April 20 2023

I, Karen Gallagher resident of 3 Findlay Road, am writing this after reviewing the revised plan dated 04/12/2023, submitted proposal for 254 New Milford Turnpike.

Son's Bedroom

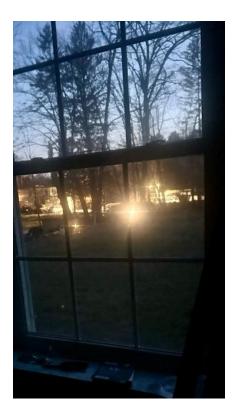
This plan does not show all of the lighting from the White Horse, and does not show reflection or glare from water or snow. This plan does indicate light trespassing over the property line will still remain.

Please note the lights are still on all night long, disrupting my family.

Property line marked in orange.
